**RE: MAJOR MODIFICATION REQUEST FOR  
AHWMMA POST-CLOSURE PERMIT (ALD 004 019 048)  
SOLUTIA INC.  
ANNISTON, ALABAMA**

**Post-Closure Permit Application Revision No. 3**

**BASIS FOR PAGE CHANGES**

**PAGE CHANGE INSTRUCTIONS**

FIGURE C-12  
Location of Piezometers  
in the Vicinity of WMA-1 and SWMU-1

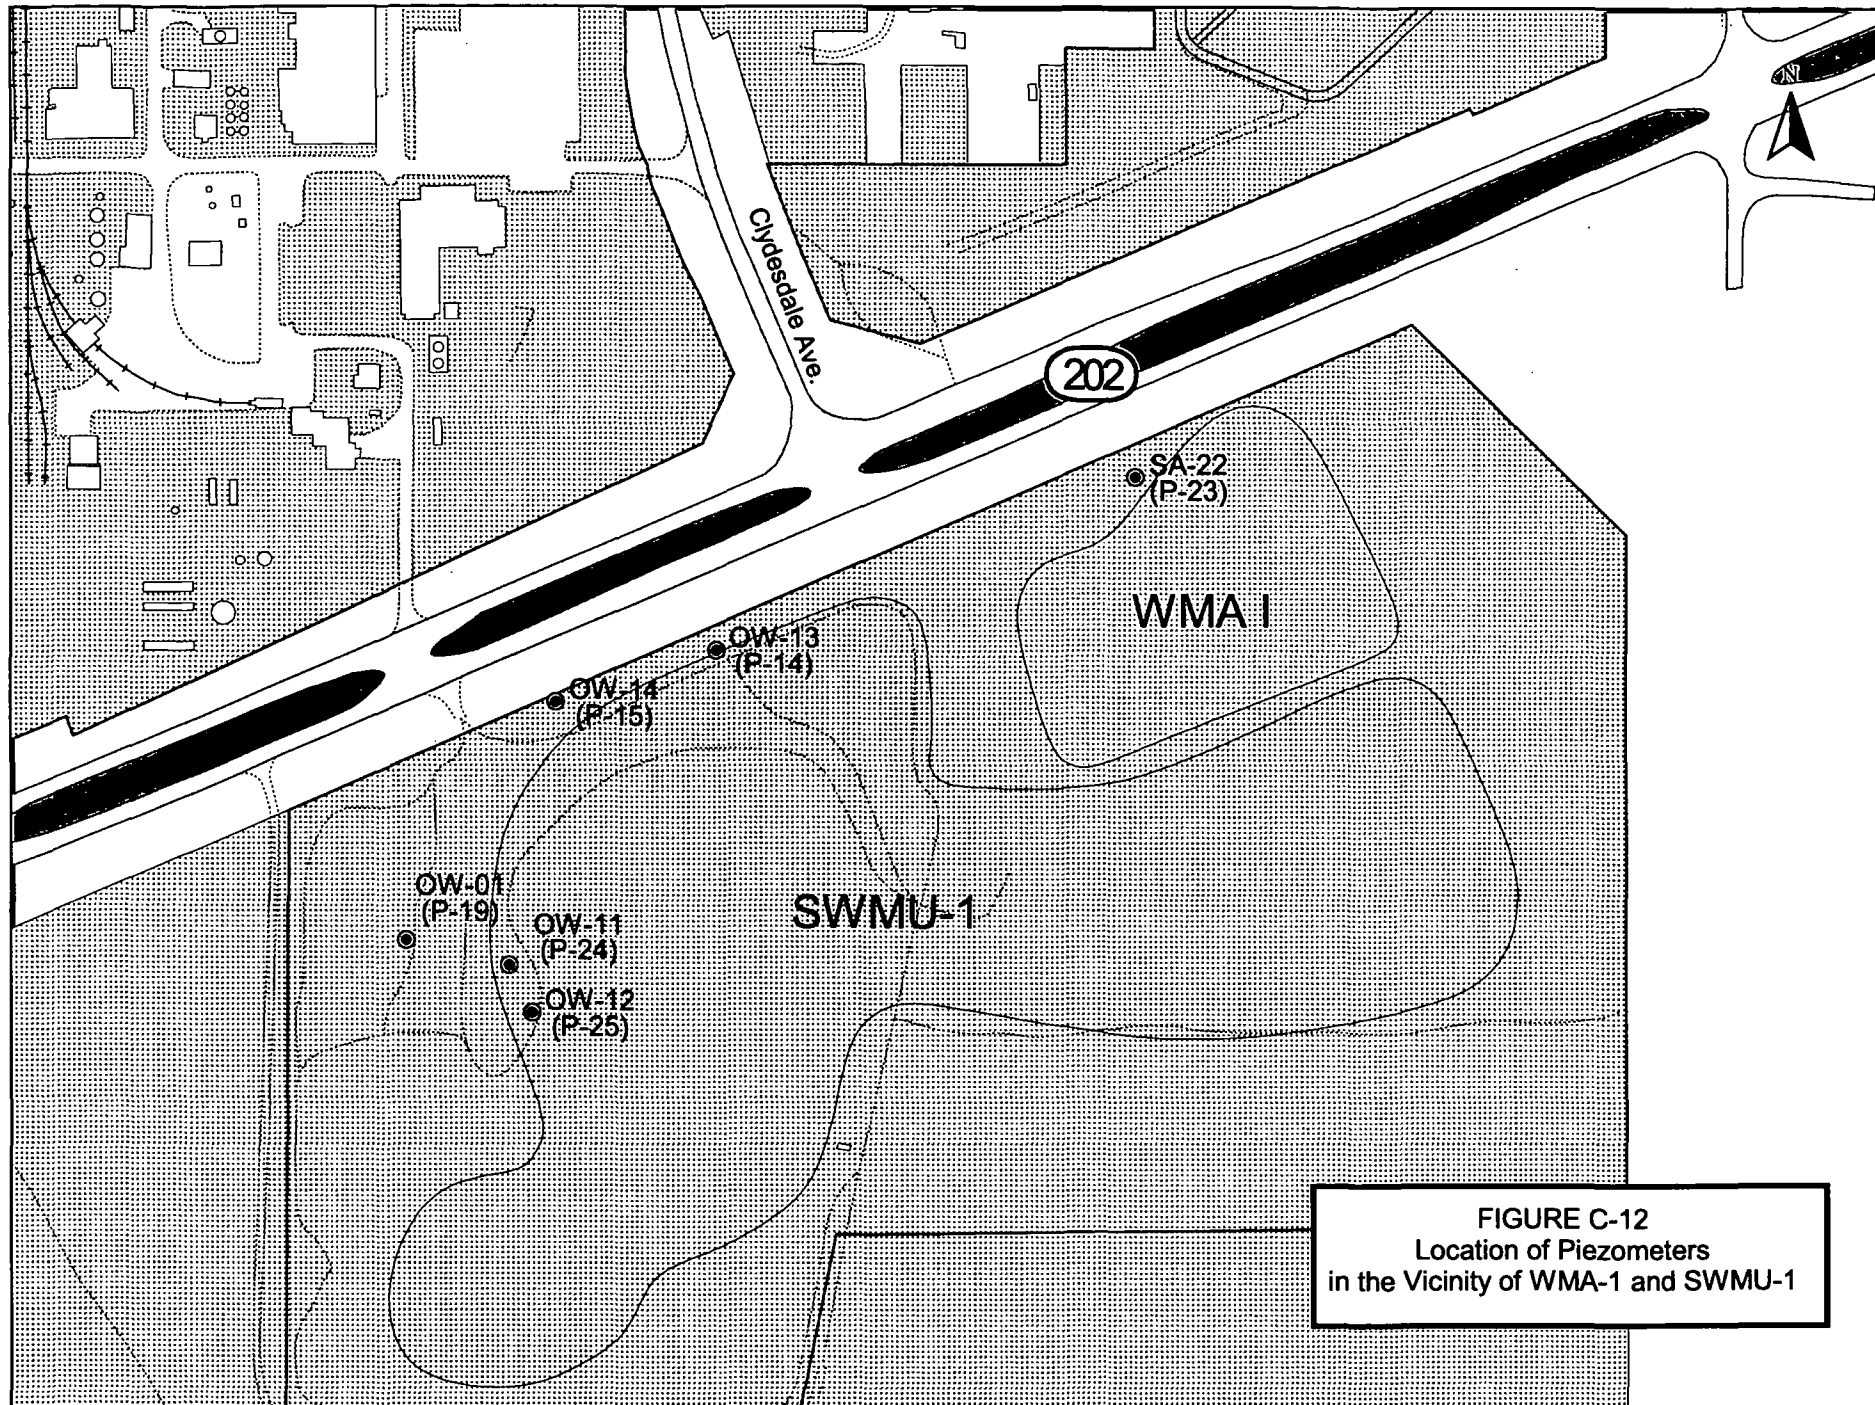
Section: C Table C-16	Page 1 of 1	Page 1 of 1	Replaced table with an updated version containing well construction details for the new wells.
Section: C Figure C-12	Page 1 of 1	Page 1 of 1	Replaced figure with an updated version to reflect the abandonment of some wells that were in the original figure.
Section: C Figure C-16	Page 1 of 1	Page 1 of 1	Replaced figure with an updated version depicting the locations of replacement wells OW-6A, OW-8A, and OW-16A.
Section: C Figure C-17	Page 1 of 1	Page 1 of 1	Replaced figure with an updated version depicting the locations of replacement wells OW-21A and MW-09A and interceptor wells IW-22 through IW-25.

FIGURE C-17  
 Detection Monitoring Program  
 and Corrective Action Program for  
 the Old Limestone Bed (SWMU 8) and WMA-II

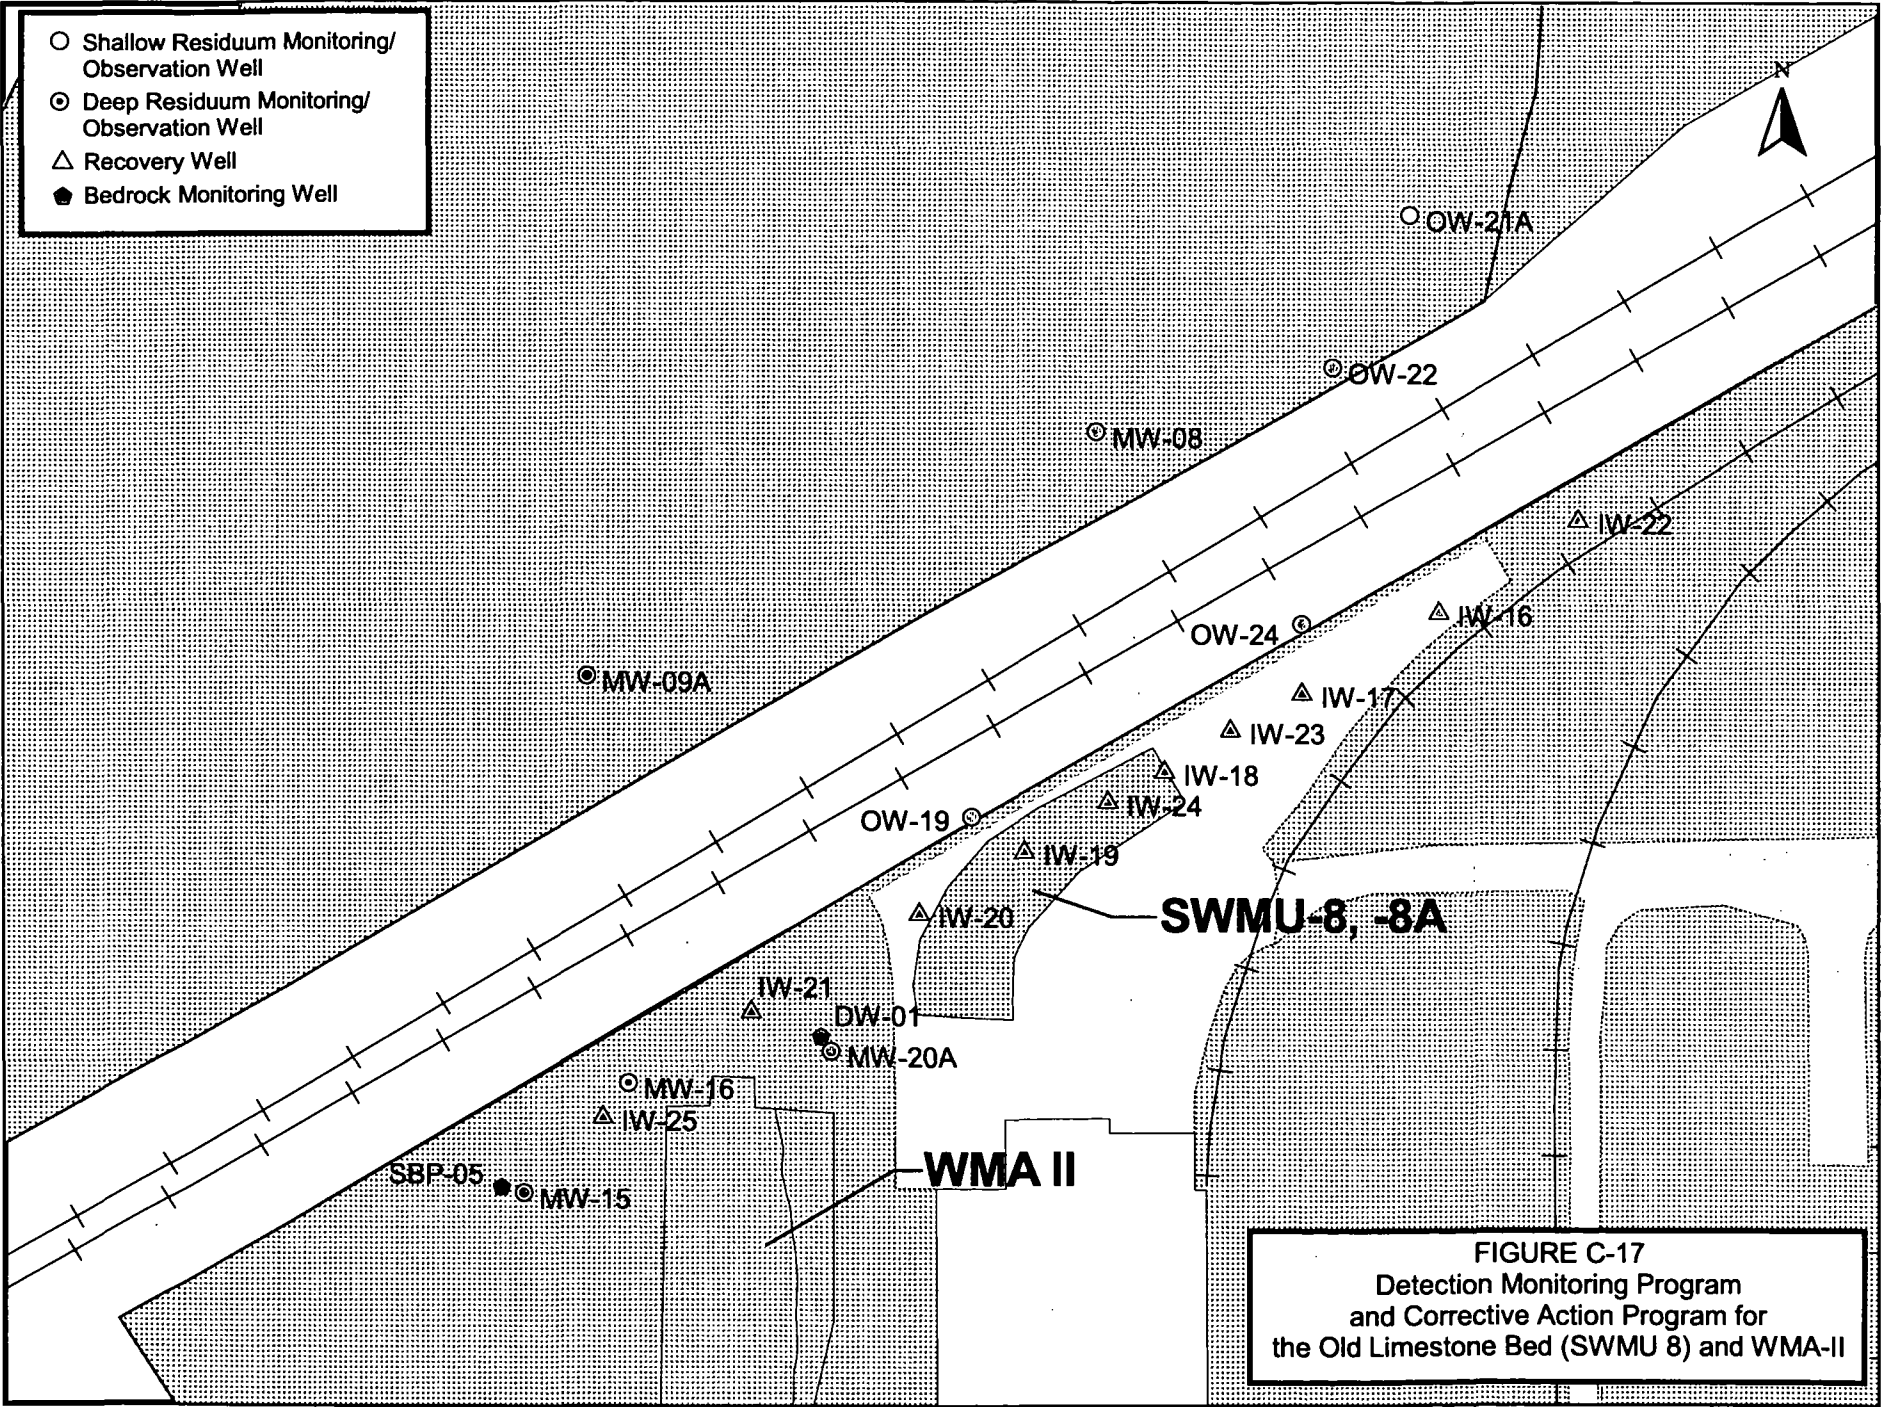
- a. Maintain groundwater monitoring wells MW-8, MW-9A, OW-19, OW-21A, OW-22 and OW-24 as boundary wells for WMA-II as specified on Table II.1. of this permit and as shown on Figure C-17 of the permit application. The boundary well monitoring system shall be operated to monitor the boundary of the plume of contamination to ensure that the plume is not migrating beyond the limits of the well system.

- b. Maintain groundwater monitoring wells MW-15, MW-16, MW20A and SBP-5 as effectiveness wells as specified on Table II.1. of this permit and as shown on Figure C-17 of the permit application. The effectiveness well monitoring system shall be operated and maintained to determine and monitor the effectiveness of the corrective action program taken to achieve the groundwater protection standard.

- c. Maintain wells IW-16, IW-17, IW-18, IW-19, IW-20, IW-21, IW-22, IW-23, IW-24, IW-25, and DW-1 as recovery wells as specified on Table II.1. of this permit and as shown on Figure C-17 of the permit application. Groundwater recovered from any on-site extraction well will be treated and/or disposed of in compliance with applicable regulations.

IW-10 FILTRATION SYSTEM DESIGN

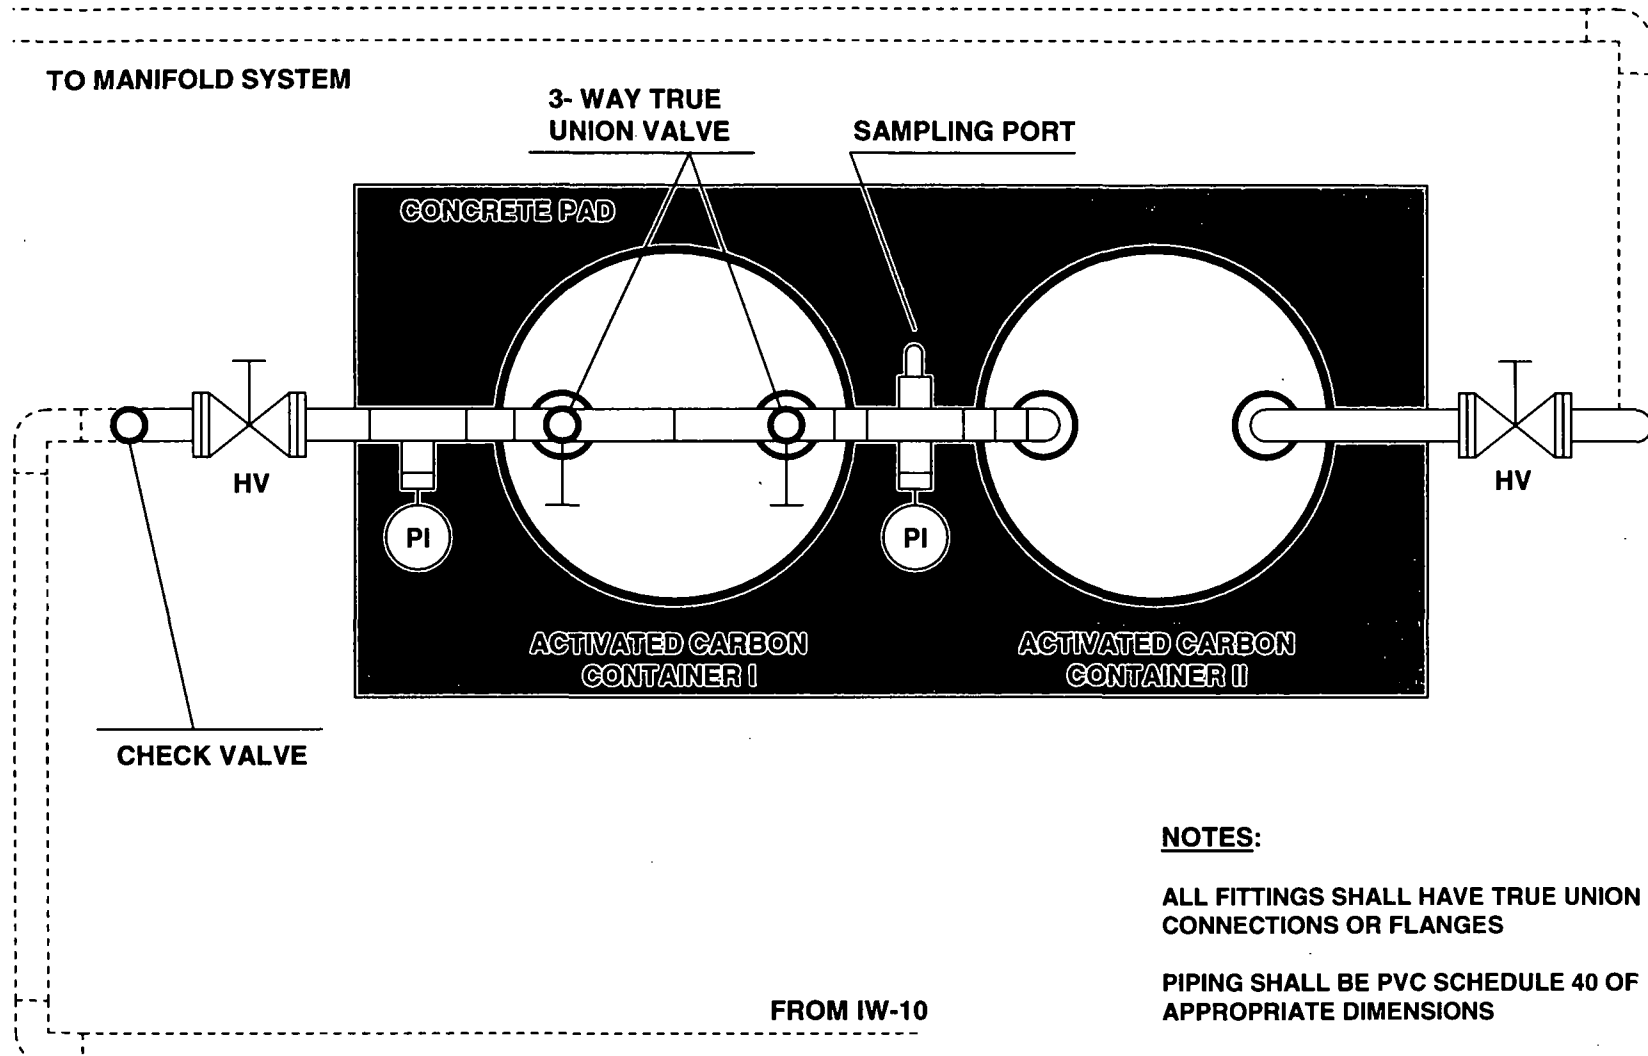
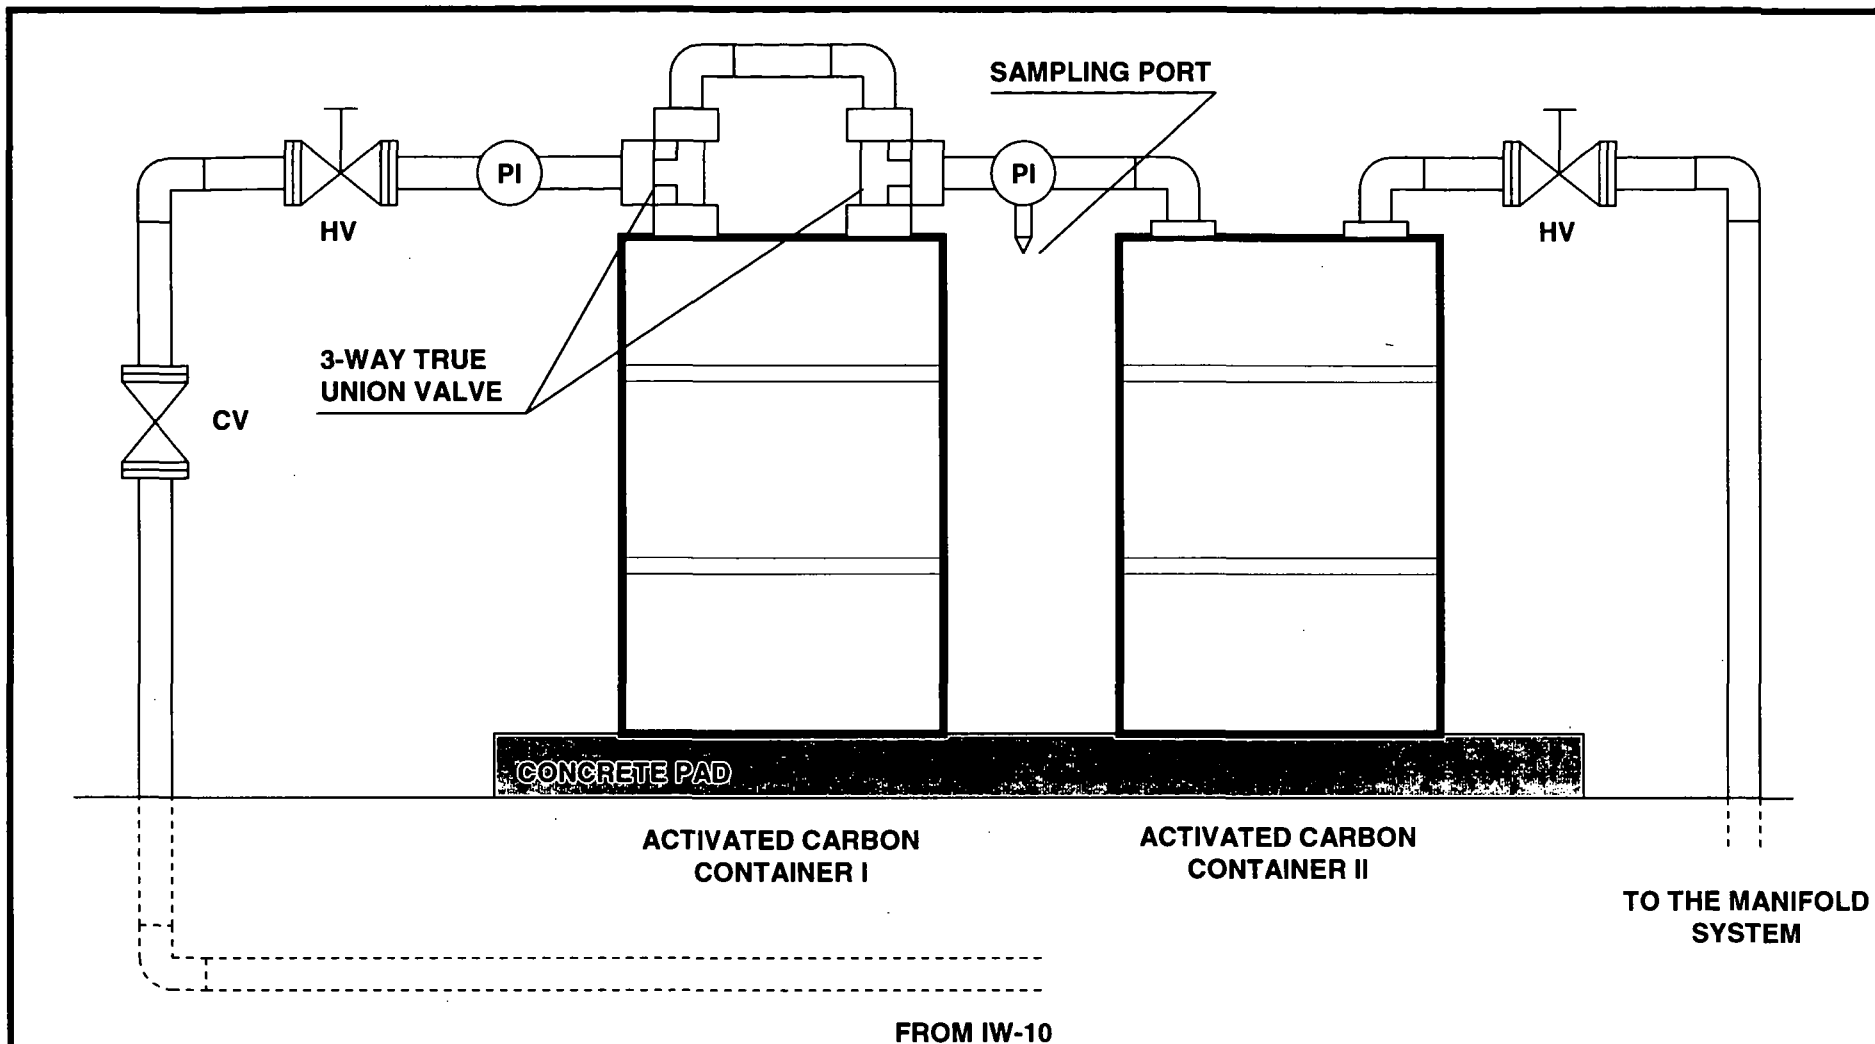
Section: C-8a(5)	Page 59 of 64	Page 59 of 64	Hanging sentence: Replaced "Monsanto's on-site biological wastewater treatment facility." with "an on-site equalization basin for subsequent discharge to the POTW, with the exception of water collected from IW-10. Groundwater from IW-10 is passed through a filtration system before it is pumped to the equalization basin. The design of this filtration system is included as Exhibit C-6."

Section: C Exhibit 1	Var.	Pages 1-9 of 9	Replaced boring logs for OW-6, OW-8, OW-16, OW-21, and MW-9 with boring logs OW-6A, OW-8A, OW-16A, OW-21A, and MW-9A, respectively.
Section: C Exhibit 6	---	Pages 1-3 of 3	Added Exhibit 6 IW-10 Filtration System Design. Changed breakthrough monitoring schedule to quarterly sampling.

The effluent has been monitored monthly since January 2004, and there have been no detections for PCBs. Therefore, once breakthrough has occurred on the first drum it will take at least one year for breakthrough to occur on the second drum. Because of this, breakthrough monitoring of PCBs on the first drum will be done on a quarterly basis. When breakthrough on the first drum or fouling on either drum has occurred, a new drum will be installed. Additionally, the following measures have been integrated into the Interim Measures Operation and Maintenance Plan for the Site: 1) weekly inspection of the piping and connections of the filtration system, 2) maintaining a weekly log of the pressure gauge values to monitor for fouling, and 3) quarterly sampling of the effluent from the first drum to monitor for breakthrough of PCBs.
